Submission Regarding Application SSI-7485-Mod-2

I object to the proposed Modification 2 to the M4-M5 Link on a number of grounds, the first and foremost being that it represents the worst aspects of ad-hoc design, destroys the intent and functionality of the approved plan, wrecks the balance achieved in the original planning process and represents a betrayal of the promise made to the local community.

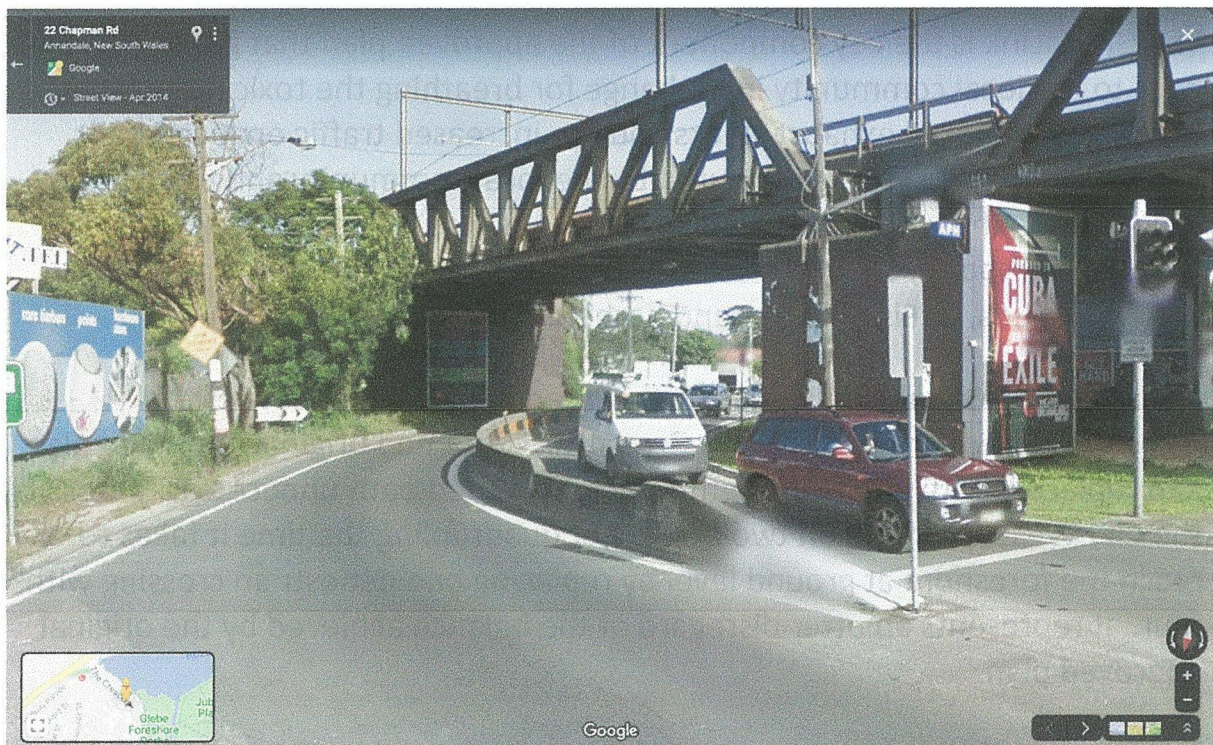
The Mod 2 proposal is poorly presented, often lacks supporting evidence for its arguments and misrepresents that actual physical situation on the ground. For example; most of the plans in the proposal do not include the substantial structure of the railway bridge and supporting structures that dominate the corner of Johnston St and the Crescent.

## Dangerous proposal to merge lanes on blind corner

The Mod 2 proposal would create an extremely dangerous situation at the tight corner under the railway bridge (see image above and point A in the image below). The Mod 2 proposal plan proposes that two lanes of traffic would merge into one on a sharp blind corner with huge brick columns that support the railway bridge.

This is a clear project risk and also pointless. The Crescent is one lane each way under the railway bridge and for the next half a kilometre (see image below).
